Access Compliance Report

Public Rights-of-Way

Intersection ID: 29131	Main Street: ALDERPOINT_LN	Cross Street: ANGWIN_PL	Location: NE
ADA ID: C558FAB0D1A7	Ramp Type: BlendTrans1	Initial Pass/Fail: Pass	Overall Compliance: No
Severity Score: 10			
Codes/Mitigation Info/Possible Solution		Field Measurements/Component Compliance

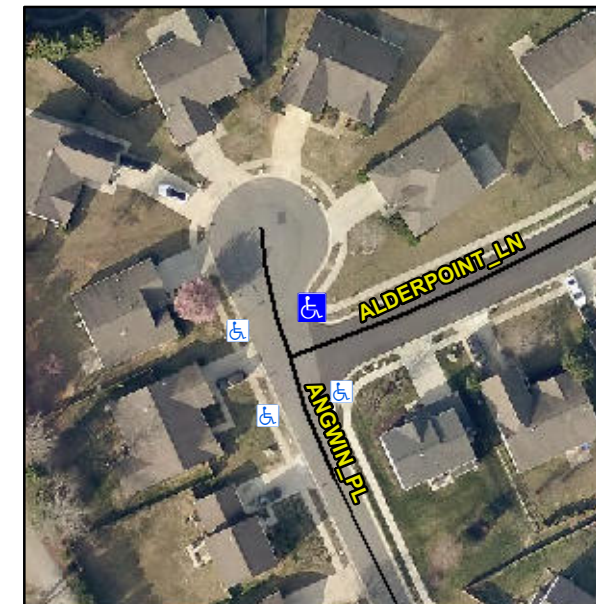
Not Found, R304.2.1, R304.2.2-Perp, R304.3.2-Para, R304.5.3, R305, R302.7

Compliance	Description	Data	Compliance	Description	Data
N/A	Ramp Length (in)	51.0	Yes	BlendTrans Slope (%)	2.7
Yes	Ramp Width (in)	120.0	Yes	BlendTrans XSlope (%)	0.6
N/A	Flare Type LT	Sloped	N/A	Flare Type RT	Sloped
N/A	Flare Slope LT (%)	1.0	N/A	Flare Slope RT (%)	1.5
N/A	Flare Traversable LT?	No	N/A	Flare Traversable RT?	No
No	Landing Length (in)	43.0	No	DWS Provided?	No
Yes	Landing Width (in)	84.0	N/A	DWS Contrast?	No
No	Landing Slope (%)	2.1	N/A	DWS Length (in)	N/A
No	Landing X Slope (%)	2.6	N/A	DWS Full Width?	No
N/A	Landing Curb? (Y/N)	No	N/A	DWS Offset (in)	N/A
N/A	Shared Landing?	No			
No	Gutter Ponding?	Yes	Yes	Gutter Slope (%)	3.1
Yes	Gutter Lip Ht (in)	0.0	Yes	Gutter X Slope (%)	1.9
N/A	Painted X Walk1?	No	N/A	Painted X Walk2?	No
	X Walk 1 Direction	To SW		X Walk 2 Direction	To SE
	X Walk 1 Width (in)	N/A		X Walk 2 Width (in)	N/A
	X Walk 1 Slope (%)	5.5		X Walk 2 Slope (%)	1.2
	X Walk 1 X Slope (%)	0.8		X Walk 2 X Slope (%)	5.5

N/A	Ramp inside XWalk1?	N/A	N/A	Ramp inside XWalk2?	N/A
	Road Slope (%)	0.1		Clear Space?	Yes
	Road X Slope (%)	5.7	N/A	Clear Space to XWalk (in)	N/A
Yes	Any Obstructions?	No	Yes	Storm Grate/Utility Hazard?	No
	Obstruction Type			Storm Grate/Utility Type	
		N/A			N/A
			Yes	Surface Condition? (G/P)	Good
			No	Curb Slope (%)	14.4

Remove & Replace Curb Ramp With Two New Directional Ramps or Equivalent.
